MFN 06-262
Supplement 4

Subject: **Modified Reactor Building/Fuel Building Truncated Model,
SER-ESB-038 Rev. 5**

**Shimizu Engineering Report SER-ESB-038, Rev. 5,
“Modified RBFB Truncated FE Model Analysis Data,”**

Project	General Electric Company ESBWR Project	Shimizu Document No.	SER-ESB-038
Title	Modified RBFB Truncated FE Model Analysis Data	Rev.	5
		Issued Date	9/22/06
		Revised Date	1/9/07

Figure C-6 Element Forces Comparison NASTRAN to ANSYS (RG FF Wall: In-plane Shear [MN/m])

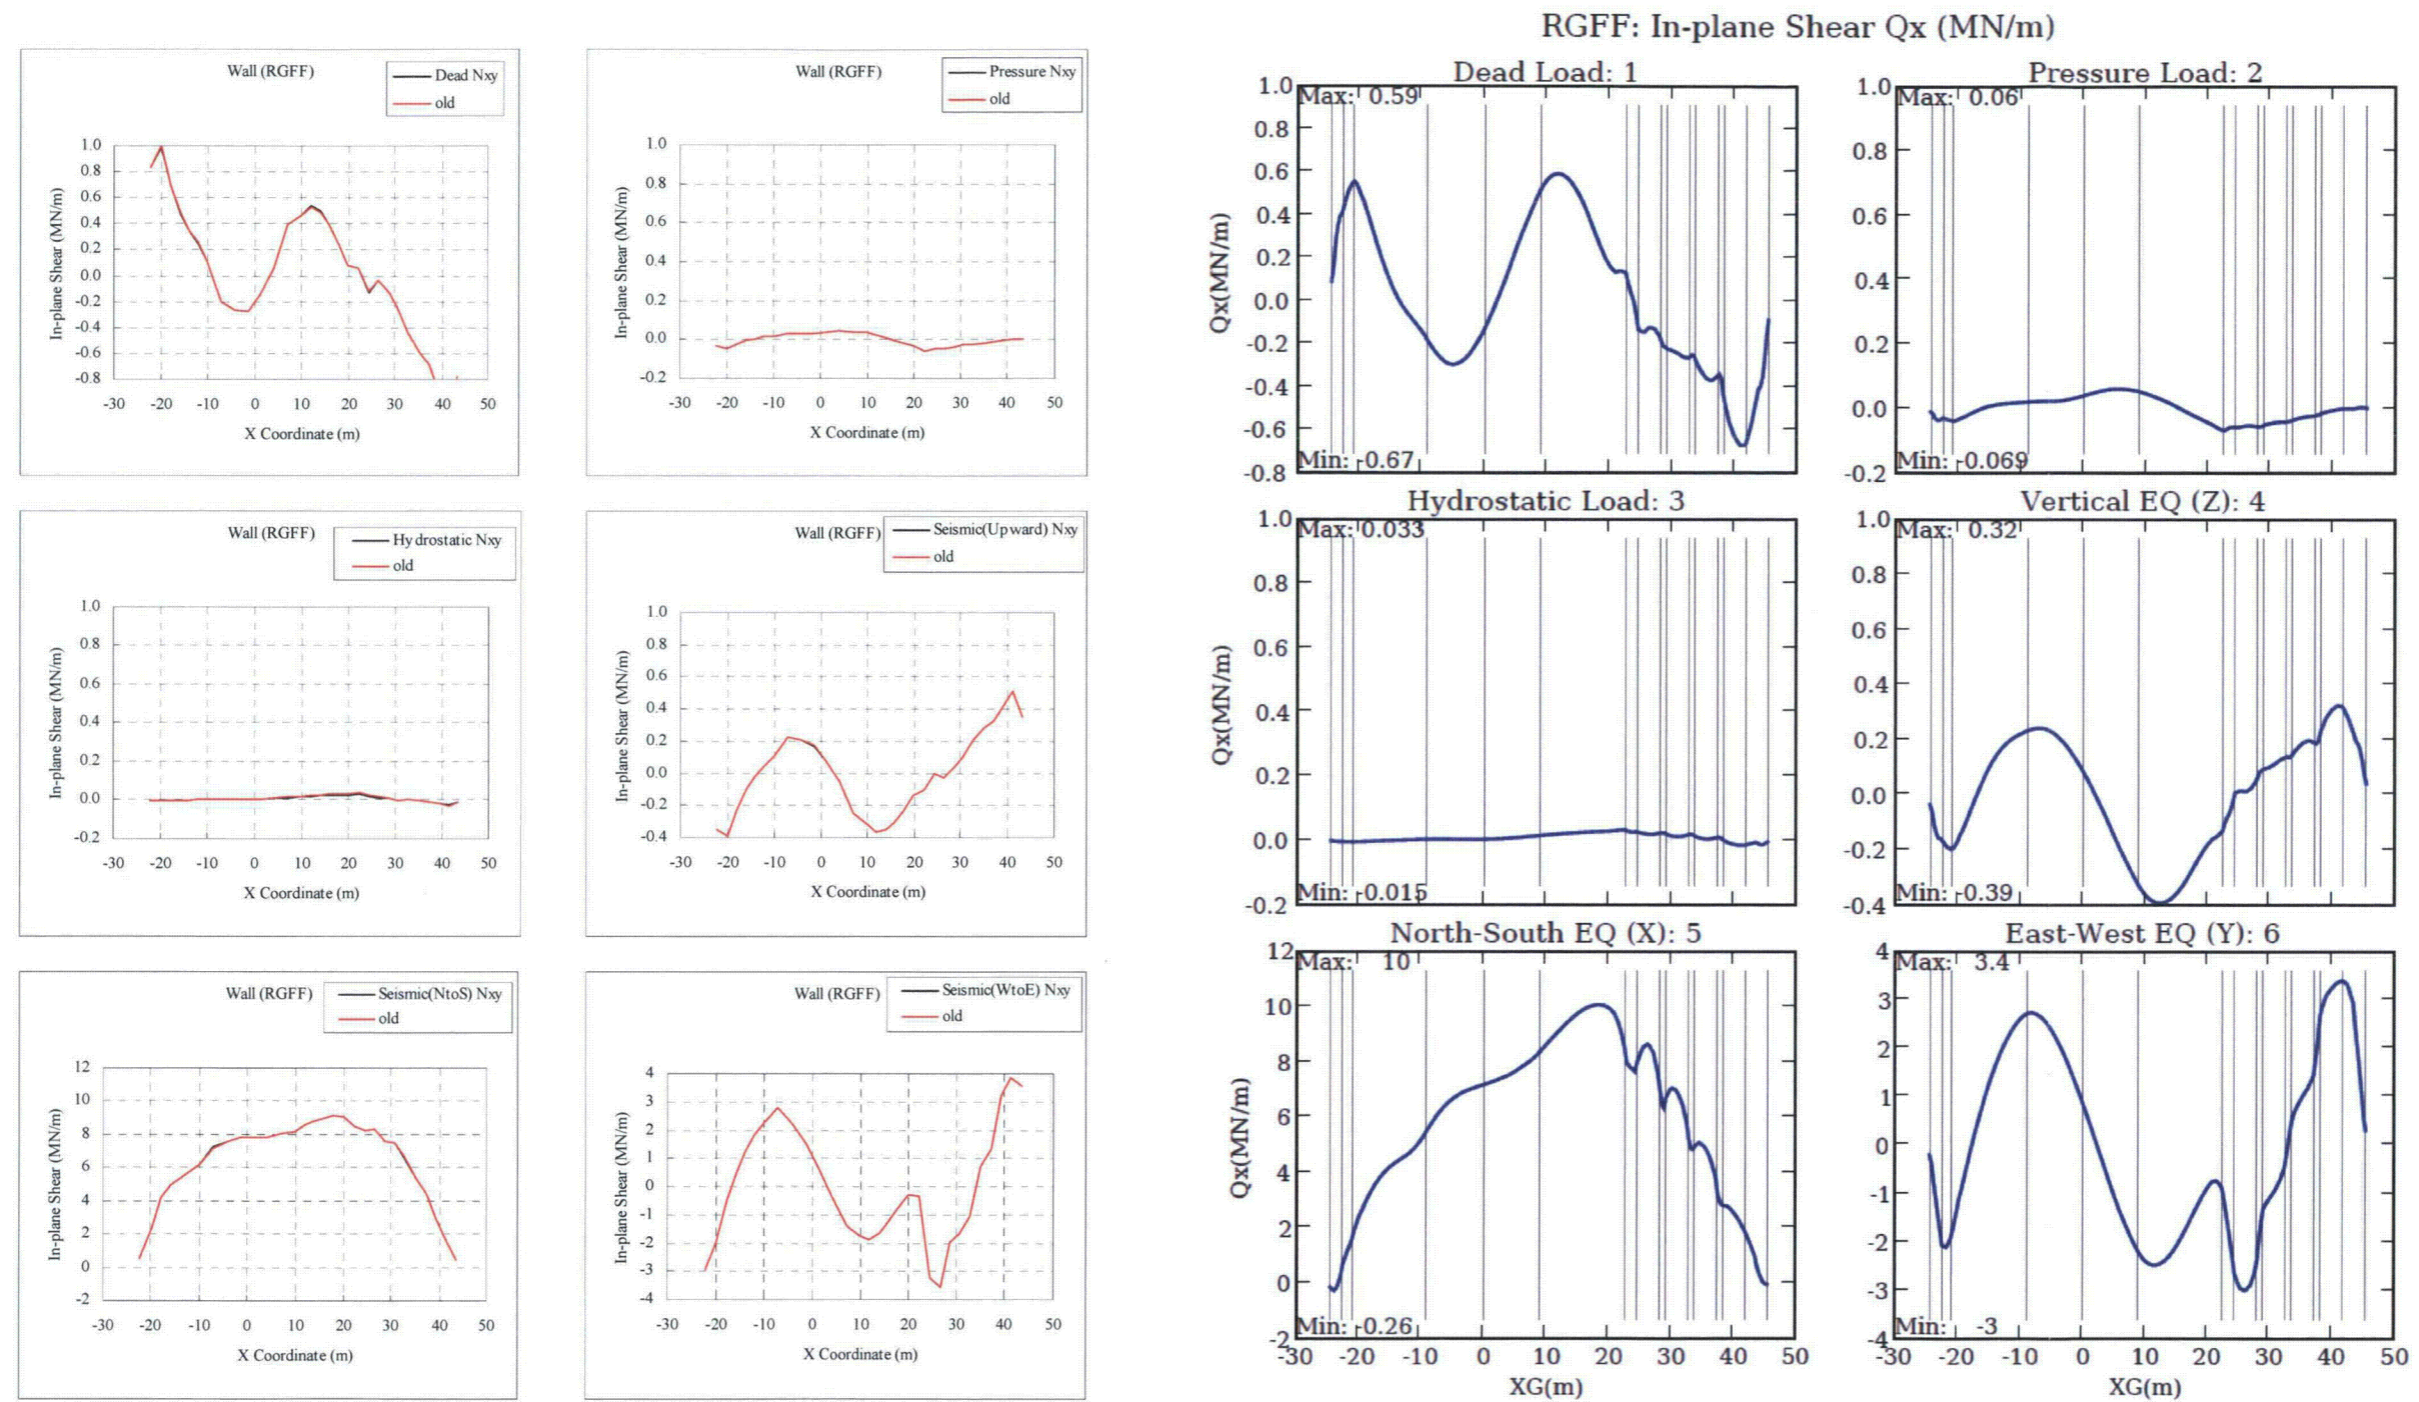
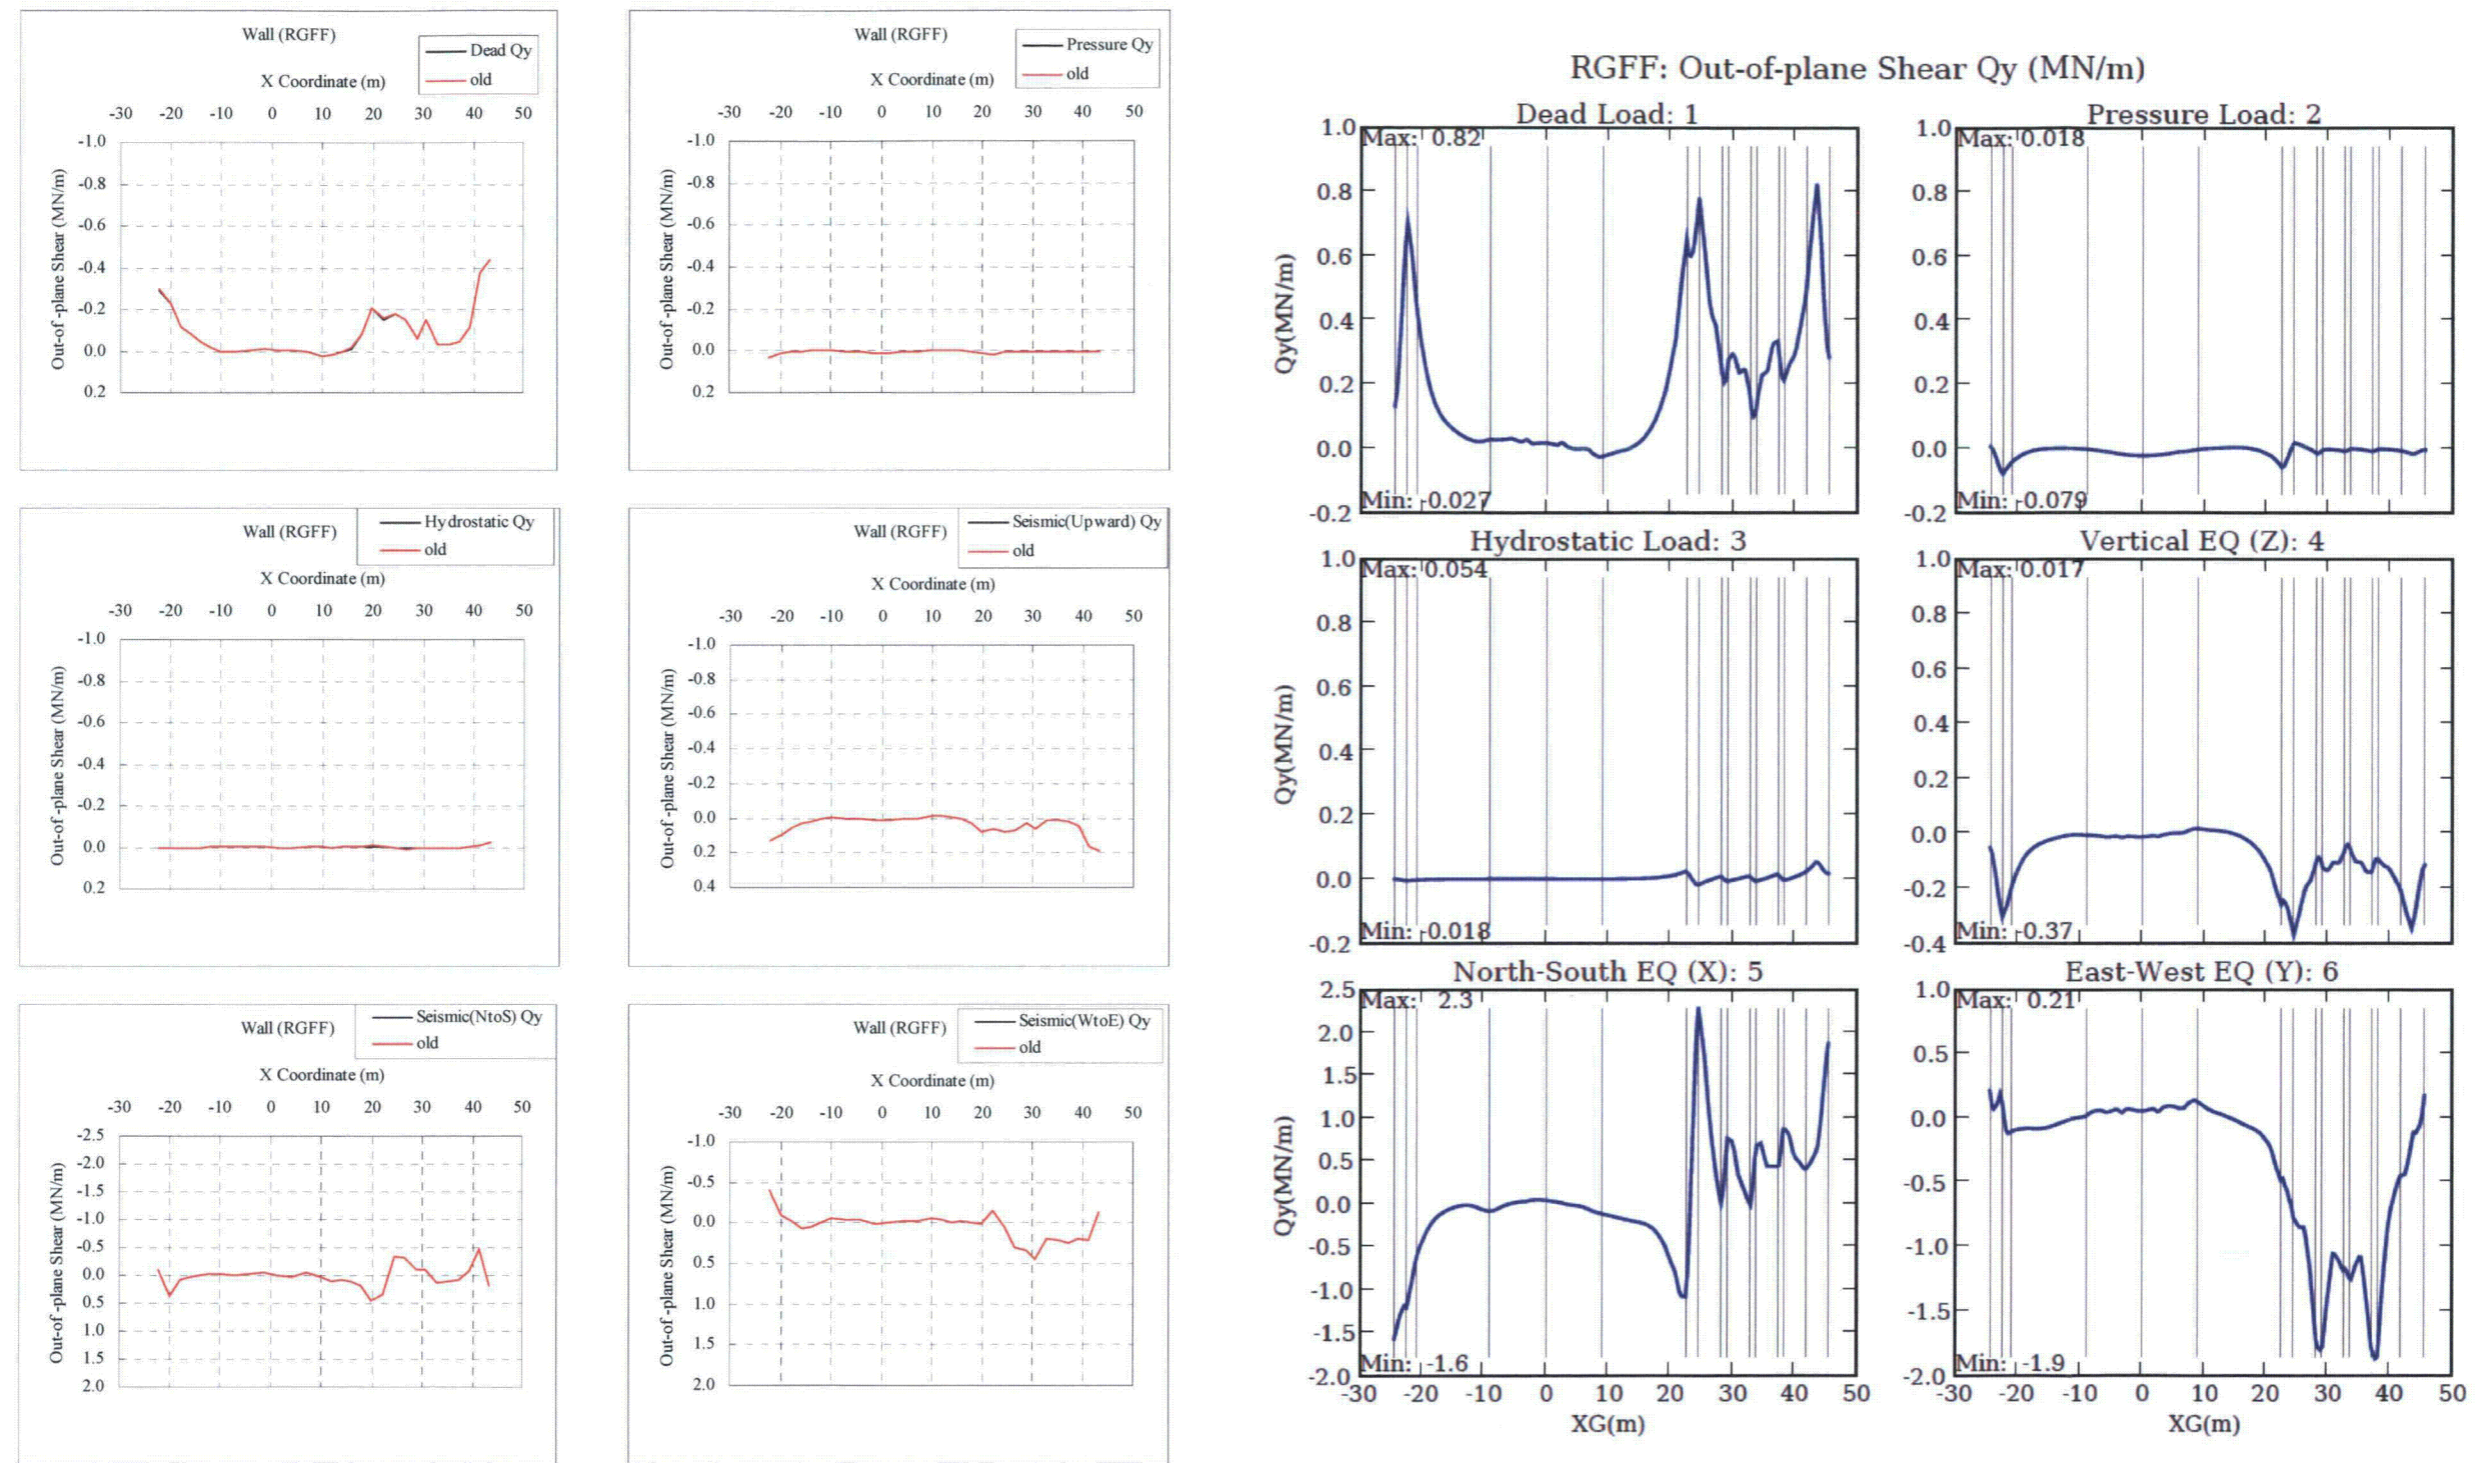
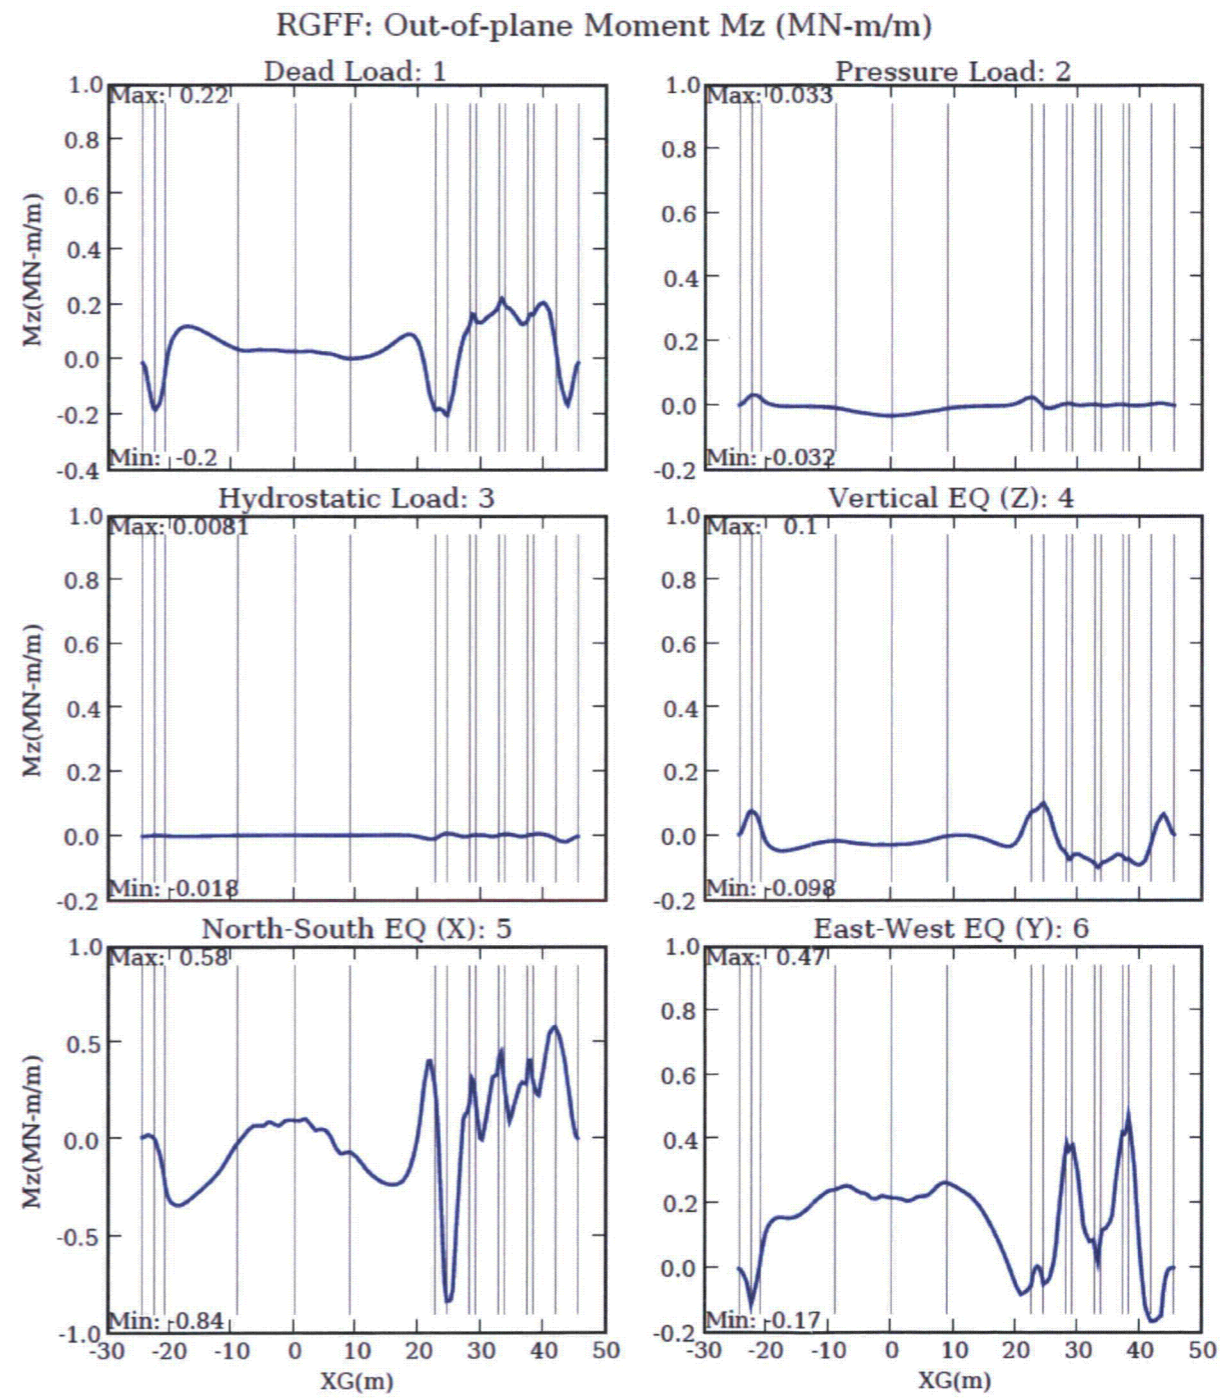
- iii) *The differences of magnitude of forces appeared on basemat inside pedestal:* The result of re-analysis using the updated model shows better agreement. In case of seismic load the magnitude of forces has to be re-compared because BNL's soil spring may not be adequate as pointed out above 3).

- iv) *The differences of magnitude of forces appeared on outer wall of Fuel Storage Pool (FSP):* For the out-of-plane shear forces and moments on RA and F3 wall located around FSP in case of Hydrostatic load, BNL's results are lower than those of GE. GE assumes the some part of differences comes from the difference of estimation levels between both models as pointed out above 8). In order to have a better understanding of the differences, GE would like to request BNL to confirm the input data for Hydrostatic load.
